James A. FitzPatrick Nuclear Power Plant
Renewed Facility Operating License No. DPR-59
NRC Docket No. 50-333

Subject: Response to Request for Additional Information in support of License Amendment Request – Proposed Changes to the Technical Specifications to Primary Containment Hydrodynamic Loads

Response to FitzPatrick request for additional information: Amendment Request for Change to the Technical Specifications to Revise the Allowable Value for Reactor Water Cleanup (RWCU) System Primary Containment Isolation (EPID: L-2019-LLA-0190)

Figure 11. Containment Peak Pressure.

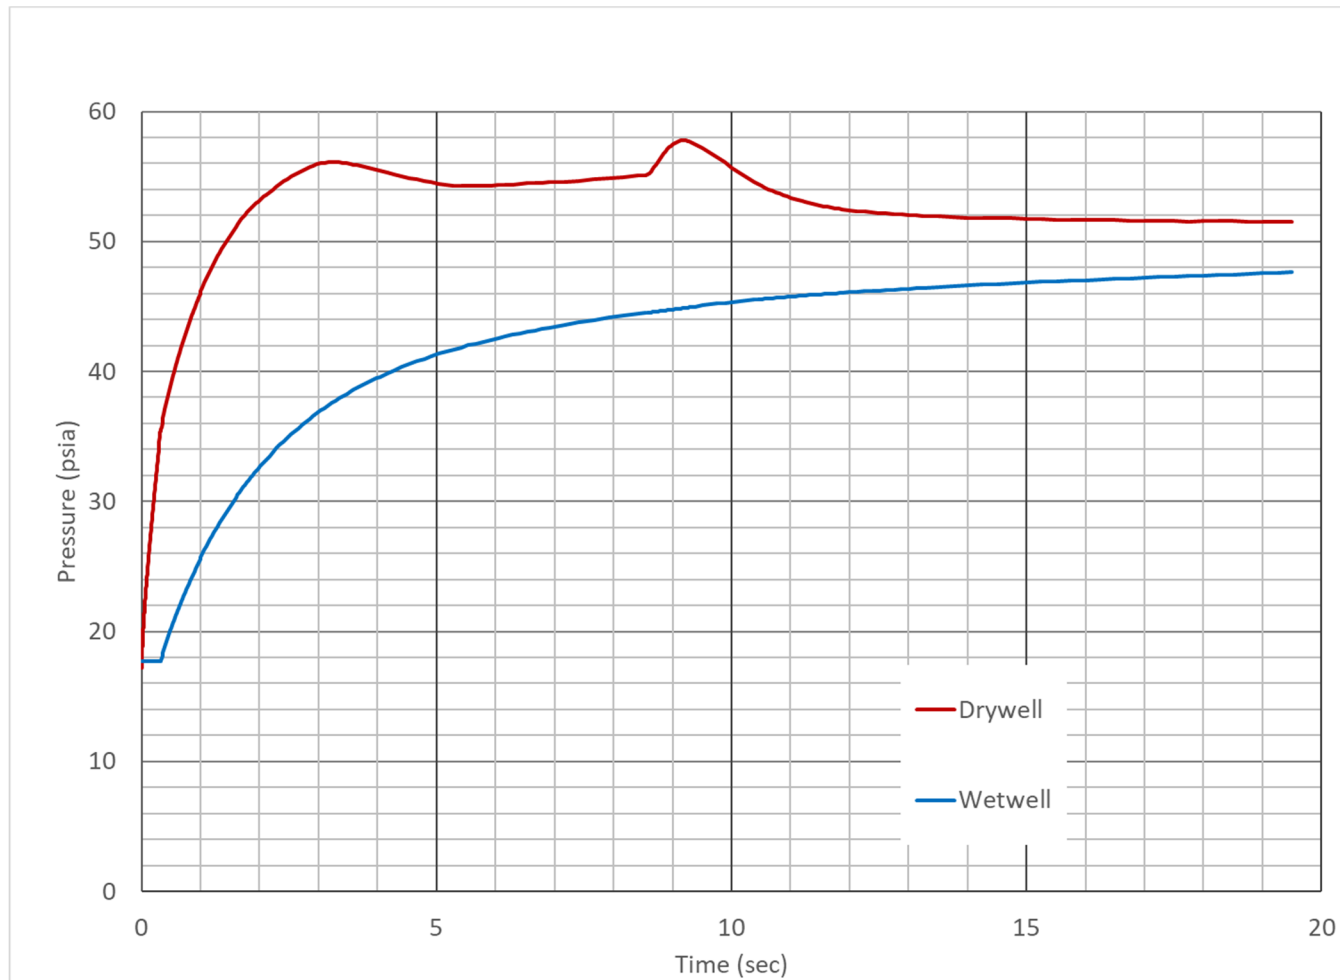
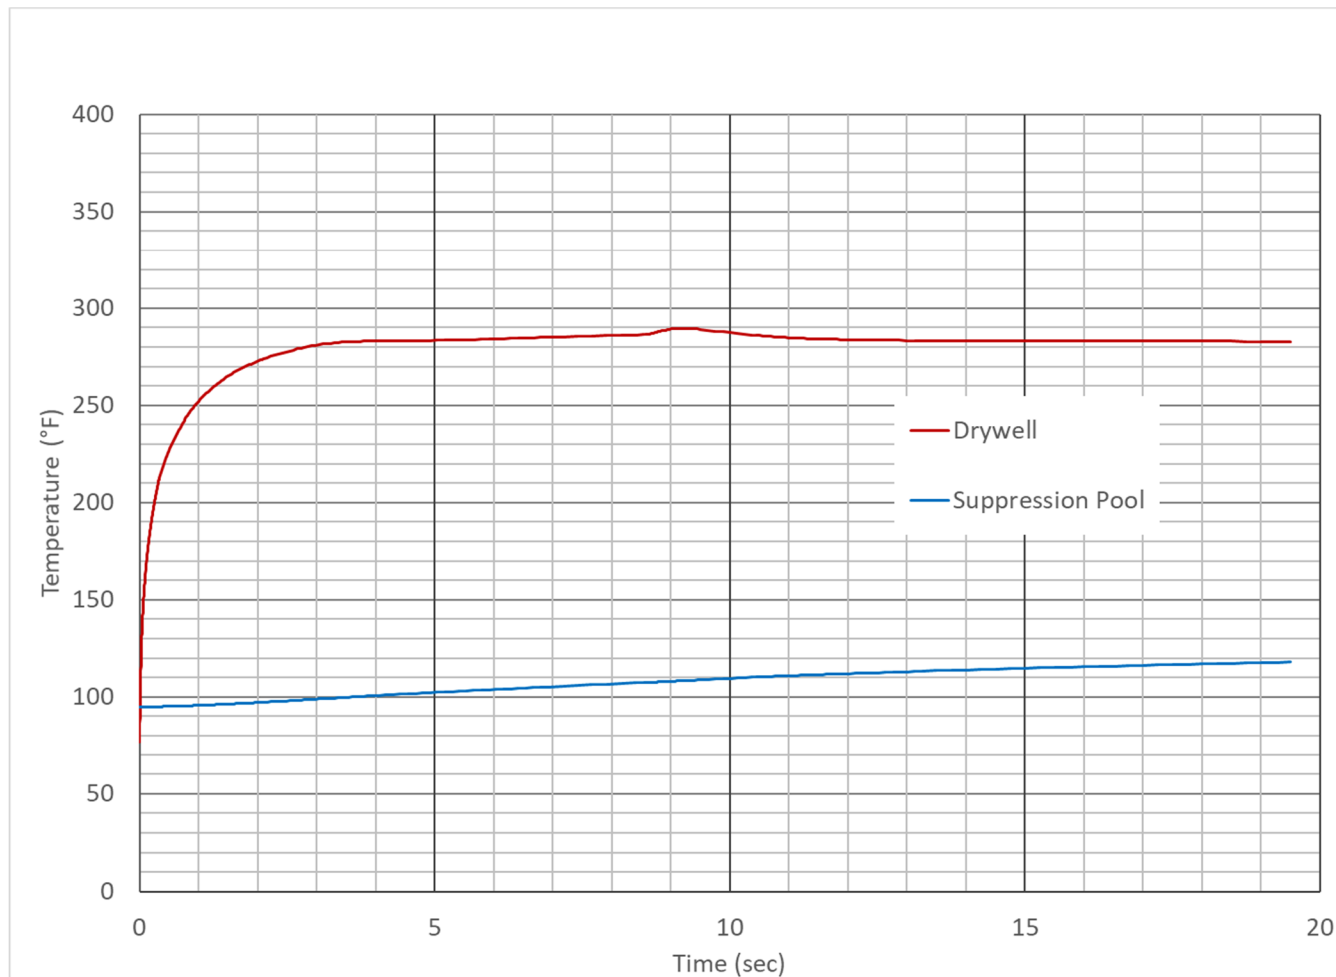
Provide containment pressure and temperature response evaluation and results, both graphs and peak values, for the above cases based on the proposed change in the suppression pool TS maximum level. In case all of the above 4 cases are not re-analyzed, provide the results of the most limiting case with quantitative justification showing that it bounds the remaining 3 cases.

Section 5.0 of 005N1724 (Attachment 2 of this letter) provides justification as to why above cases 1 and 2 are the bounding cases for this analysis. Containment peak pressure and temperature were recalculated for both cases and the results are provided in Table 3 of 005N1724. The bounding pressure and temperature histories are plotted in Figure 11 and Figure 12 of 005N1724.
